Docket Nos. 50-3
and 50-247

The Commission has issued the enclosed Amendment No. 33 to Facility Operating License No. DPR-5 and Amendment No. 92 to Facility Operating License No. DPR-26 for the Indian Point Nuclear Generating Unit No. 1 and Unit No. 2. The amendment consists of changes to the Technical Specifications in response to your application transmitted by letter dated September 29, 1983.

Amendment No. 33
License No. DPR-5

Amendment No. 92
License No. DPR-26

Figure 3.1 Facility Management and Technical Support Organization

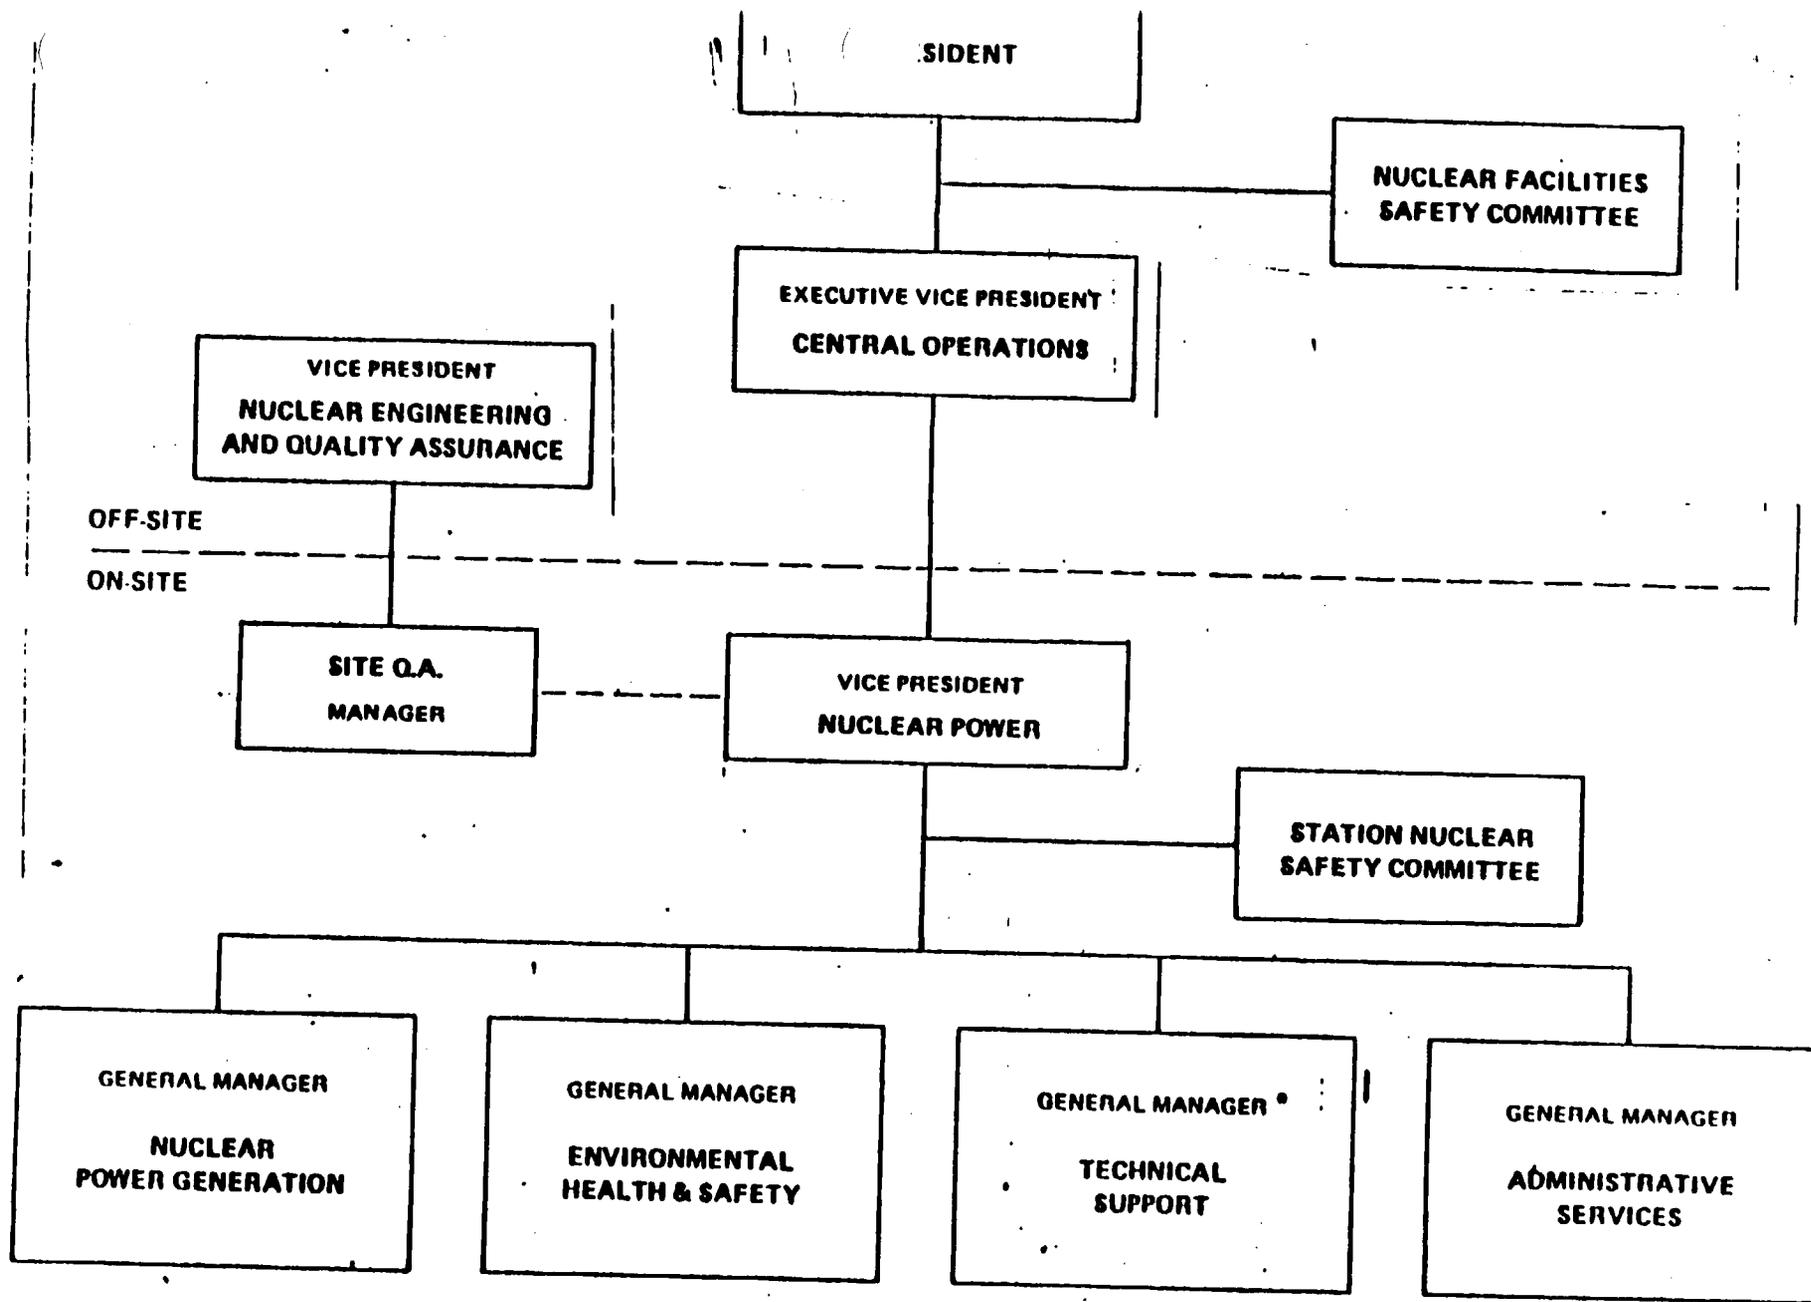
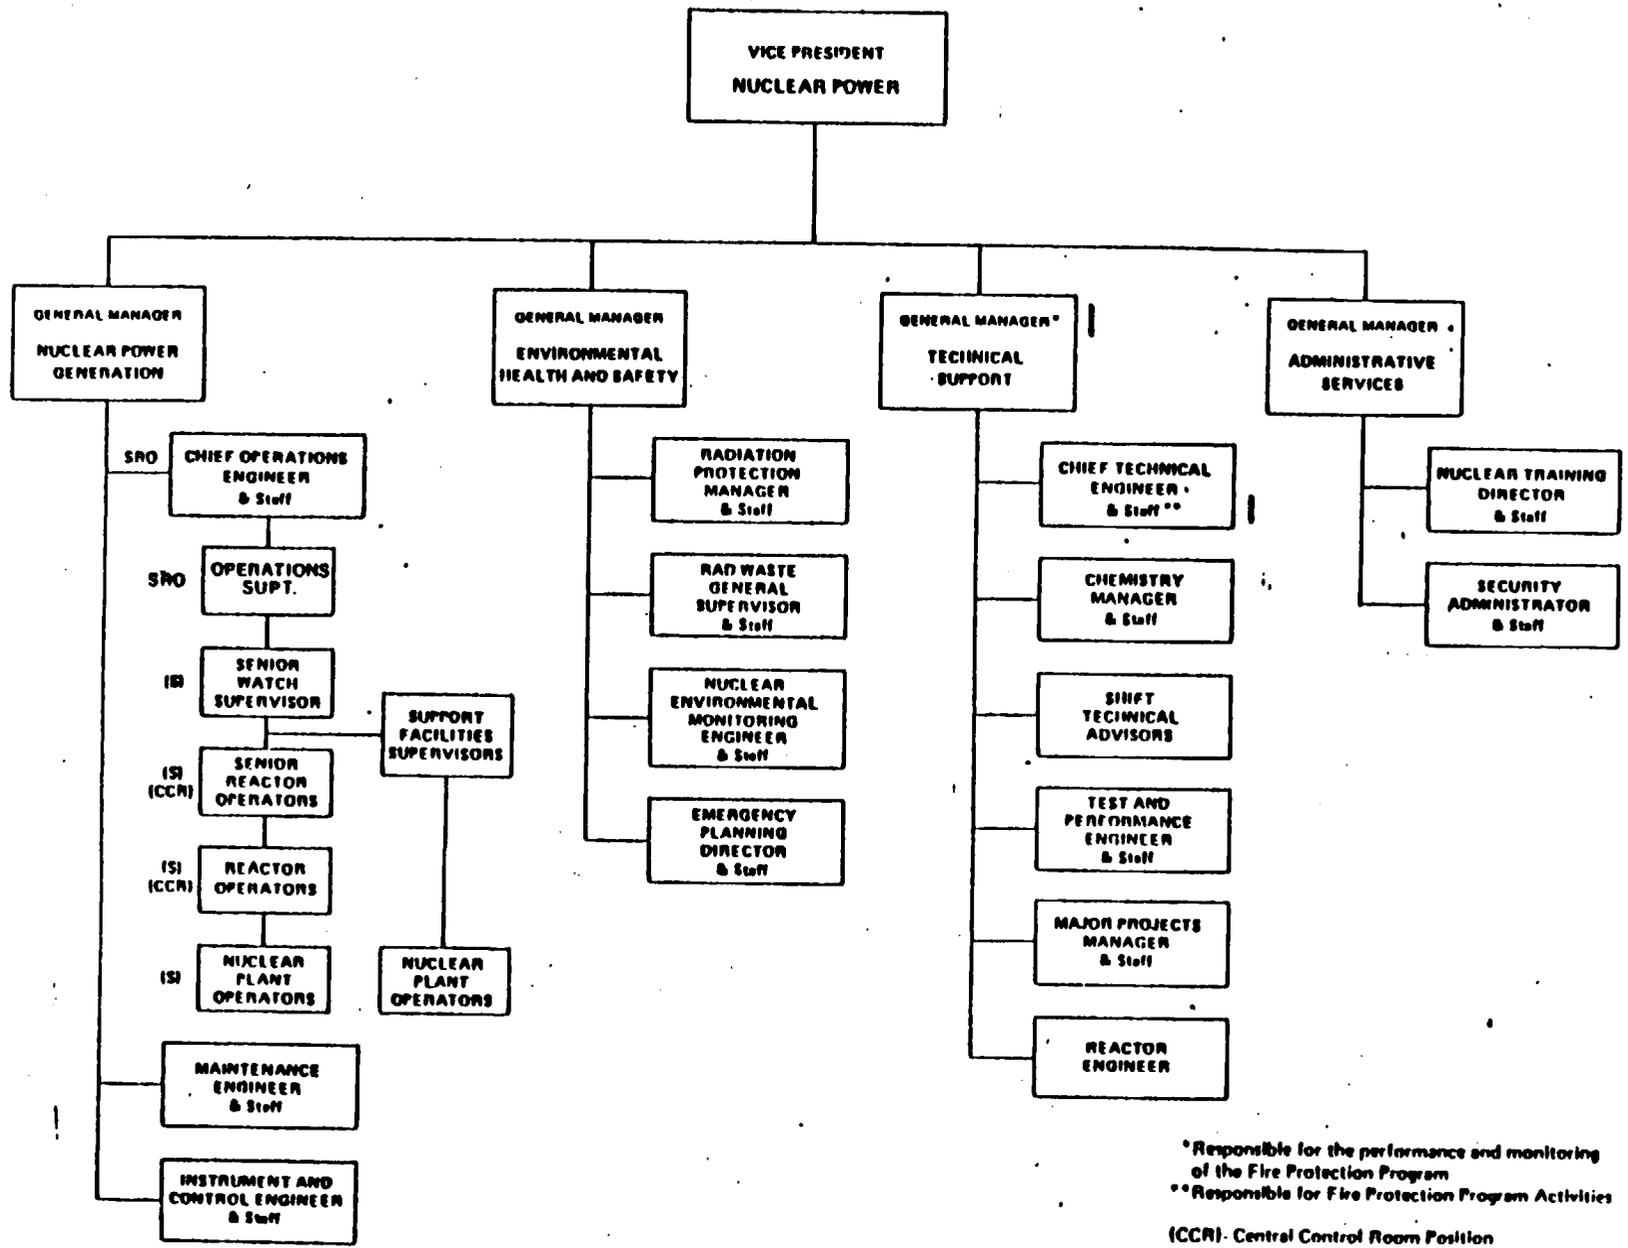
The amendments revise Figures 3.1 and 3.2 of the Indian Point Unit No. 1 Technical Specifications and Figures 6.2.1 and 6.2.2 of the Indian Point Unit No. 2 Technical Specifications thereby consolidating the fire protection responsibilities of the Fire Protection and Safety Administrator with those of the Fire and Property Protection Engineer. The amendment also changes the number of copies of the monthly operating report sent to the Office of Inspection and Enforcement and deletes the requirement to send the report to Office of Management Information and Control.

*Responsible for the performance and monitoring of the Fire Protection Program

* Responsible for the performance and monitoring of the Fire Protection Program
 ** Responsible for Fire Protection Program Activities

Consolidation of these positions will place the responsibility for all fire protection requirements under a single general manager (Technical Support). This organizational change should reduce the potential for omission, overlap or duplication of effort by assuring that all fire protection related activities at the plant site are administered by a central organization having the appropriate and necessary expertise.

Figure 6.2-1 Facility Management and Technical Support Organization

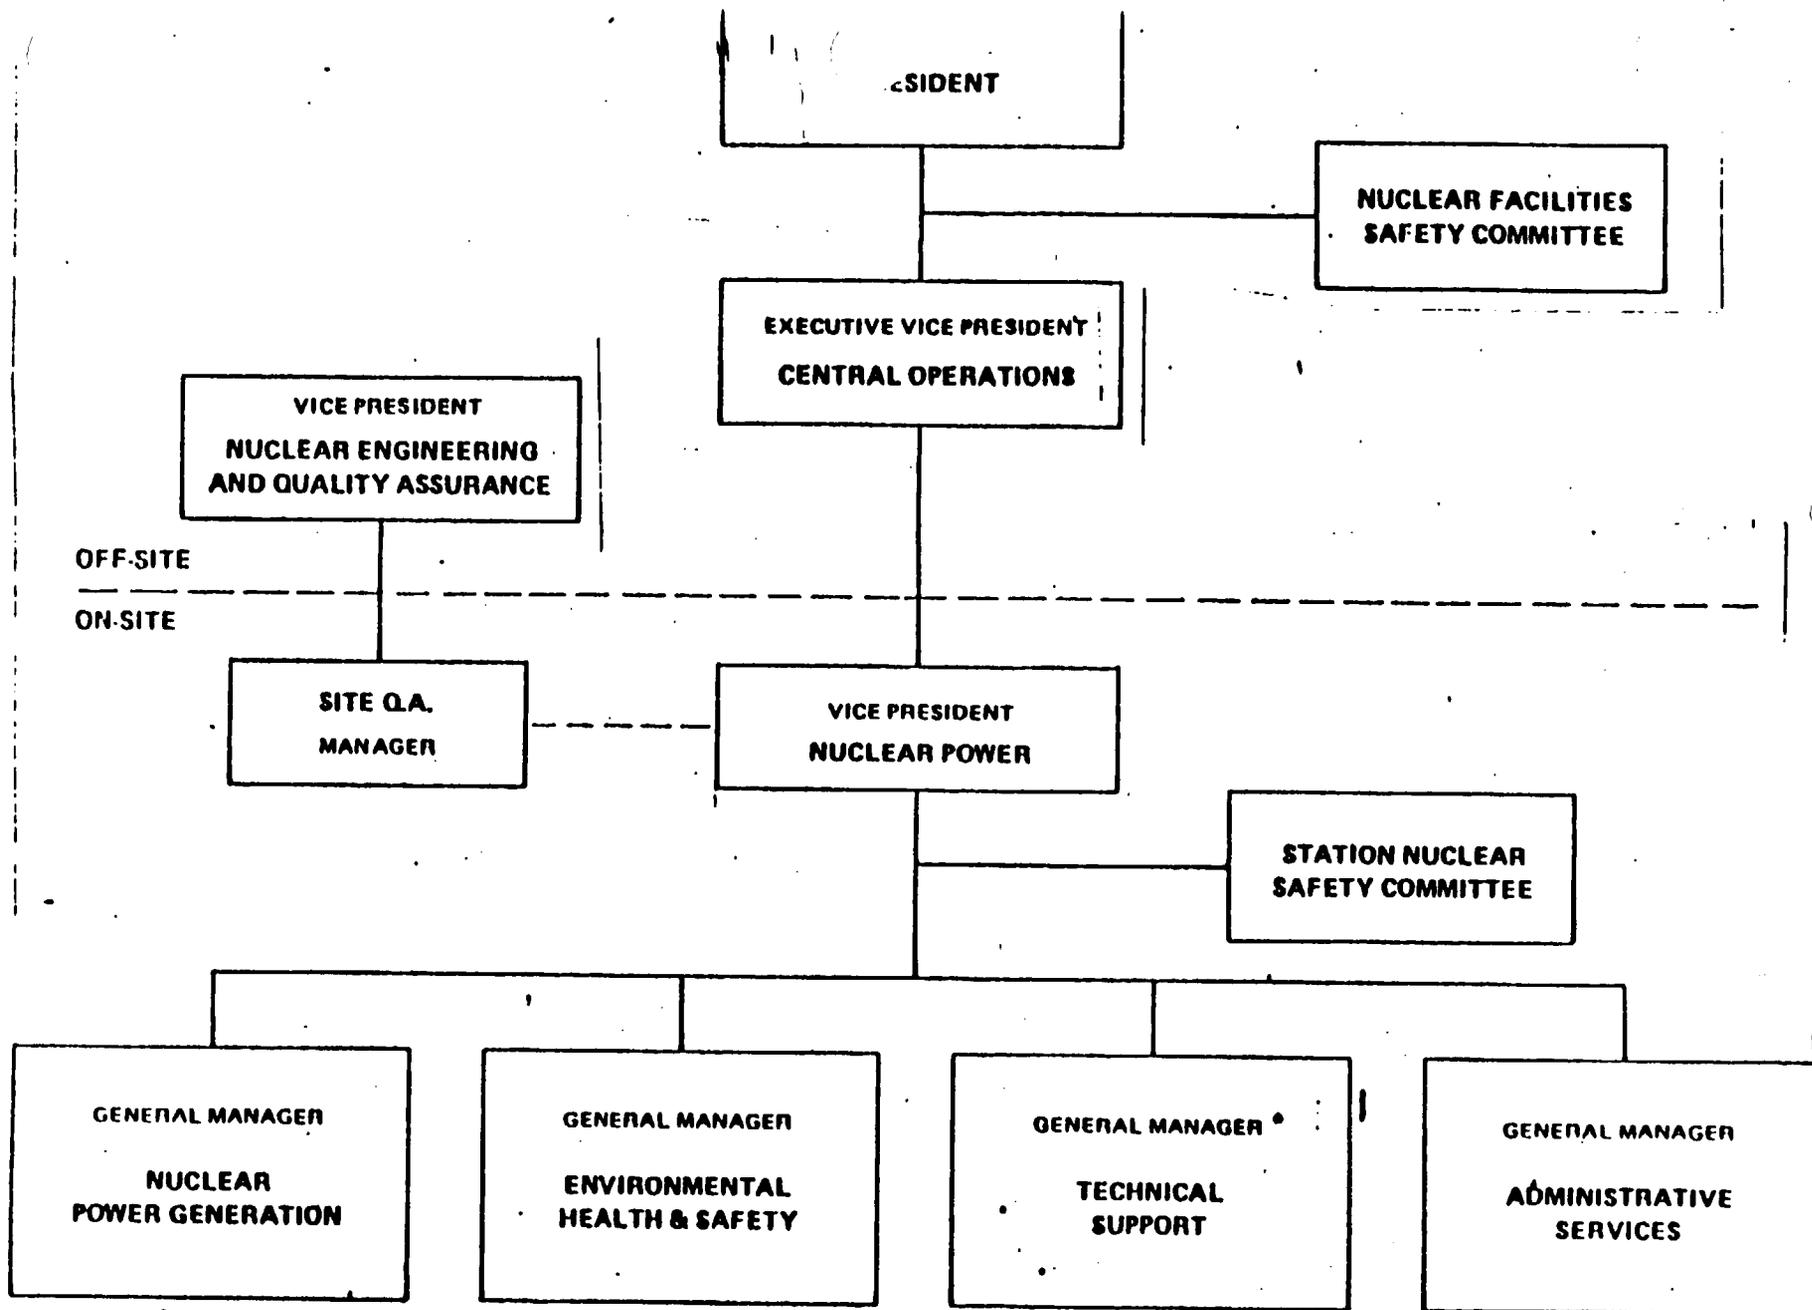
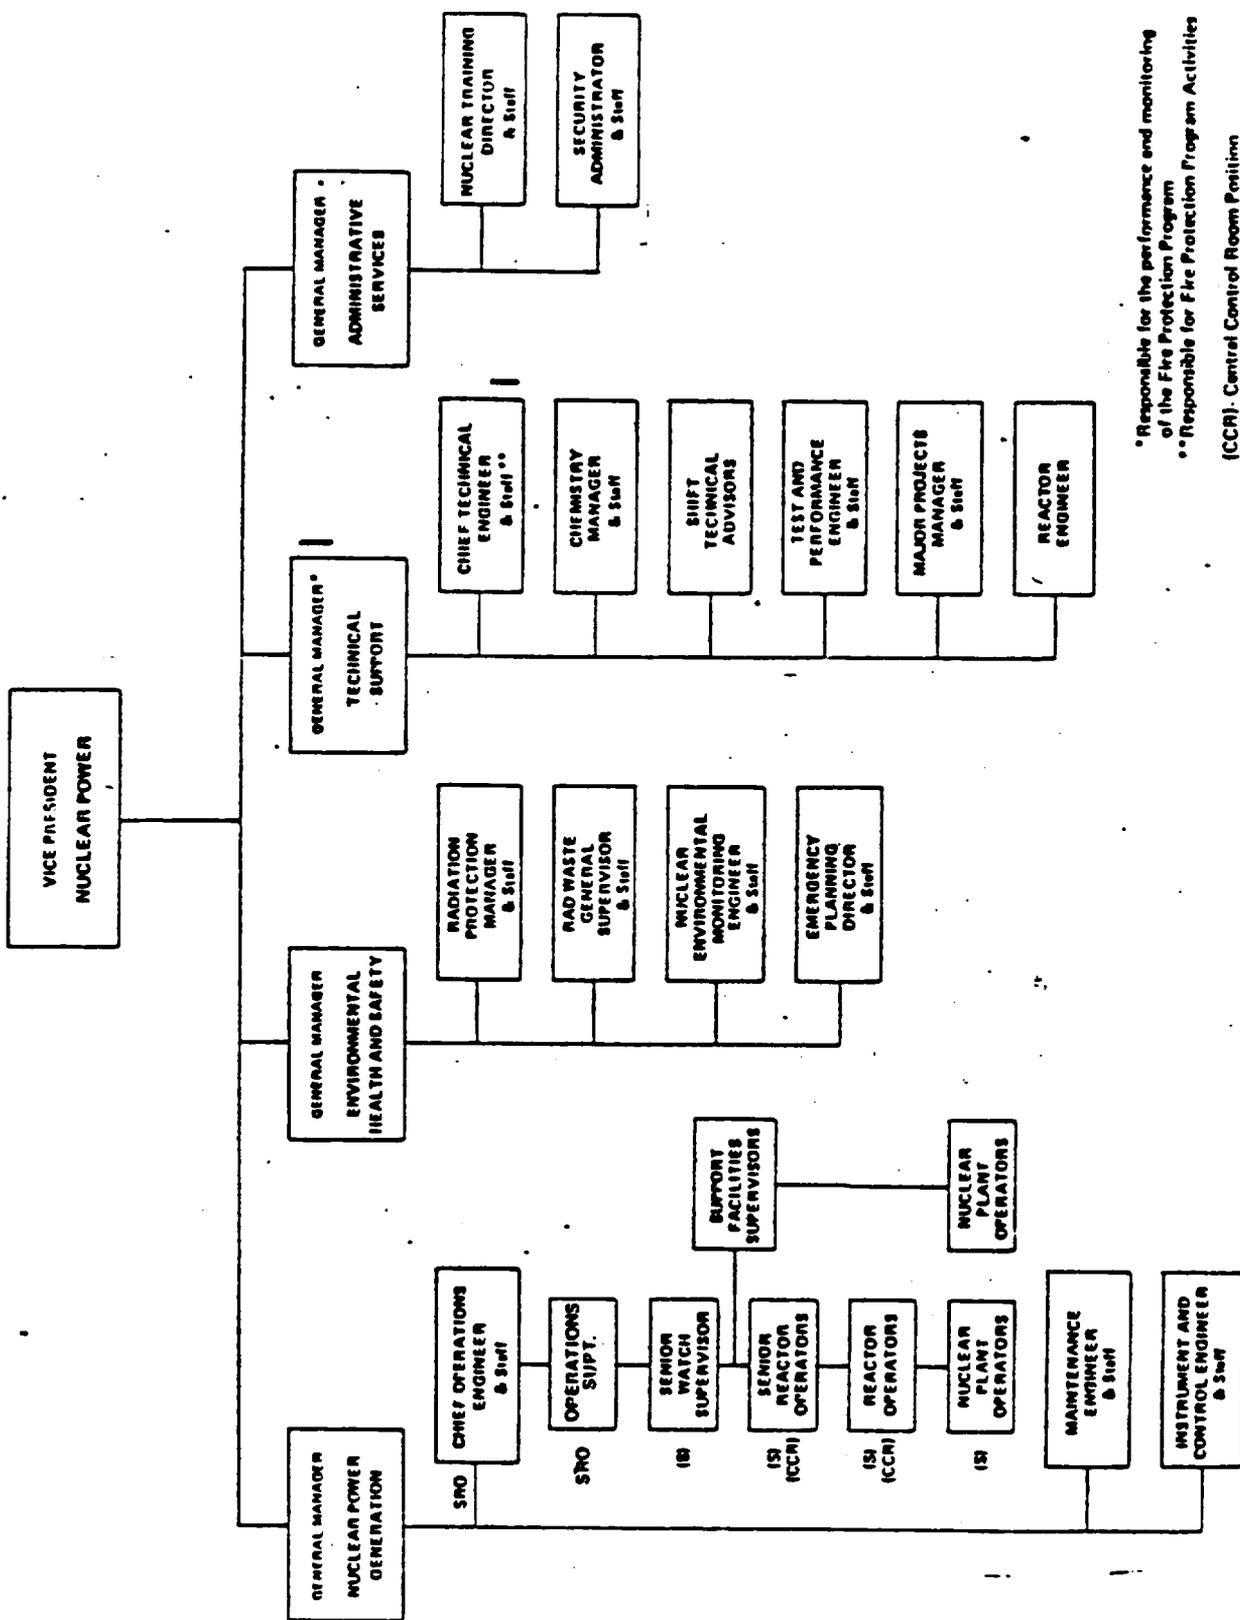
*Responsible for the performance and monitoring of the Fire Protection Program

* Responsible for the performance and monitoring of the Fire Protection Program
 ** Responsible for Fire Protection Program Activities
 (CCR) - Central Control Room Position
 (S) - Continuous Shift Coverage
